CHATHAM AREA TRANSIT AUTHORITY IFB 2024-06, ADDENDUM NO. 1

PROJECT: CAT Hybrid Ferry Vessels

Questions posed during initial Q&A Period and CAT's Responses:

END OF ADDENDUM NO. 1

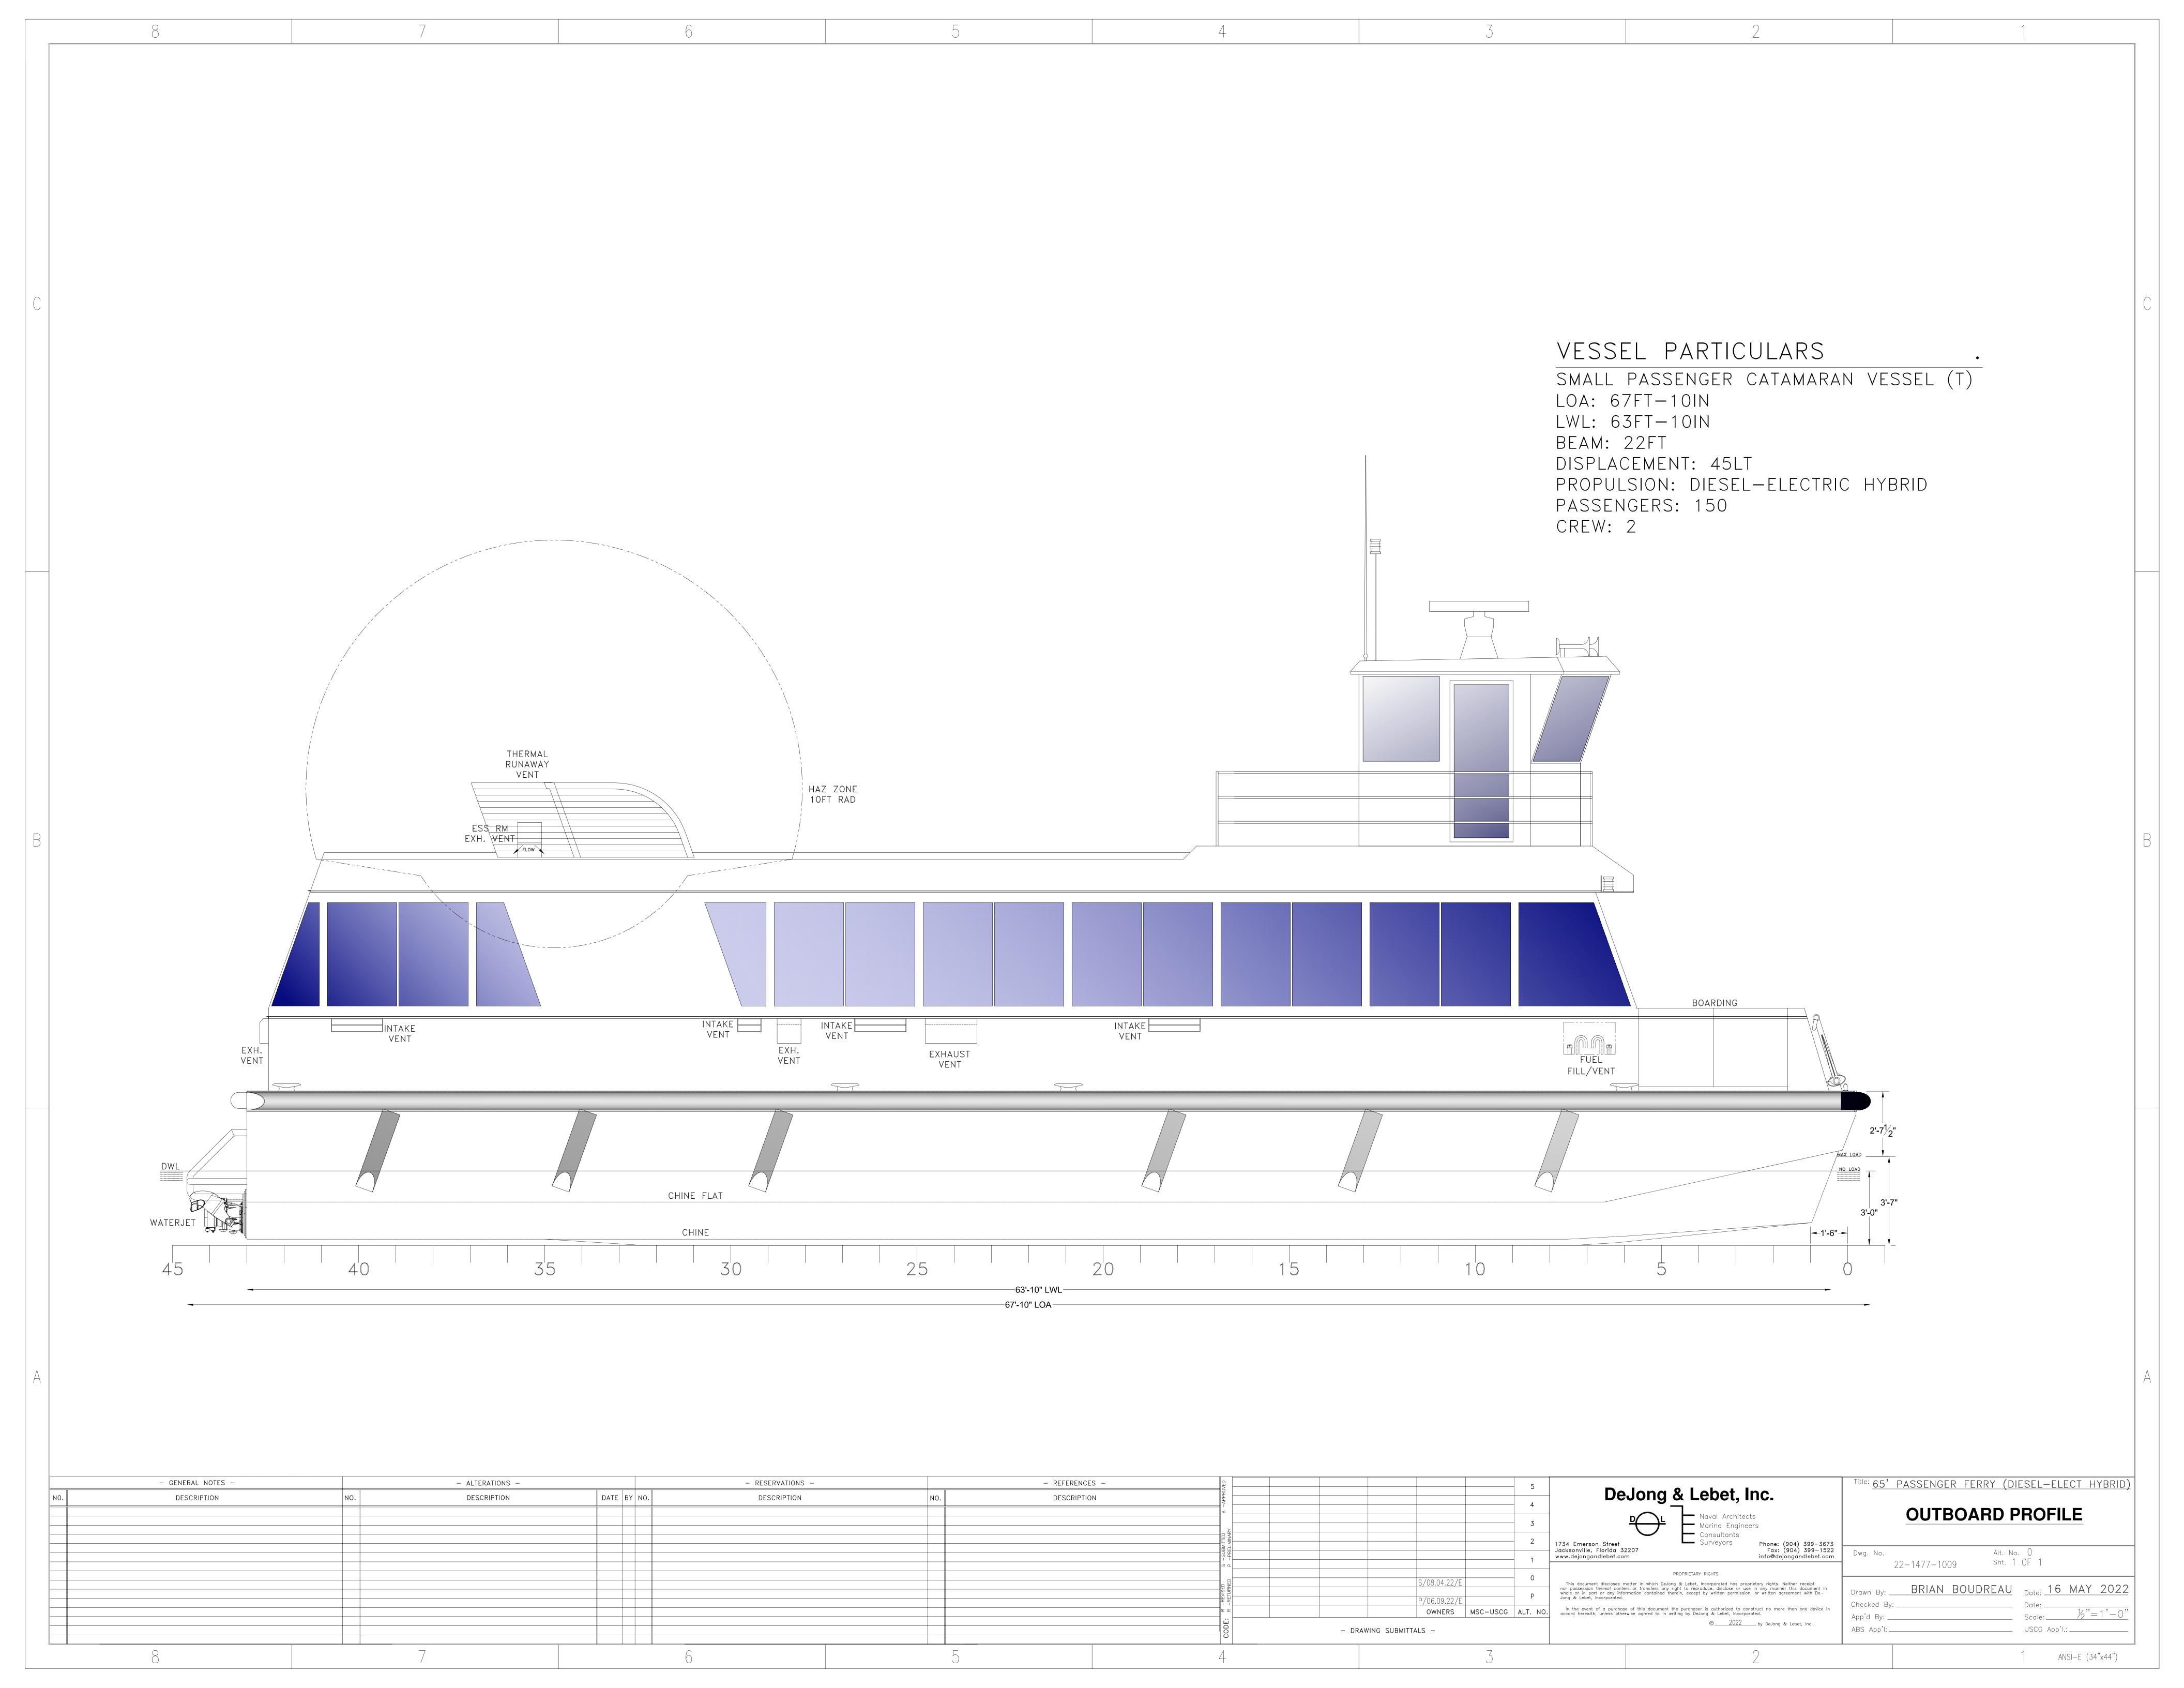
Question 9: Can you please provide me with Dwg. #22-1477-5001 & 5002 that is referenced

in the outline specifications for the 65'X21'-4" Passenger Vessel.

Response: See Plans attached #22-1477-5000 - 5002.
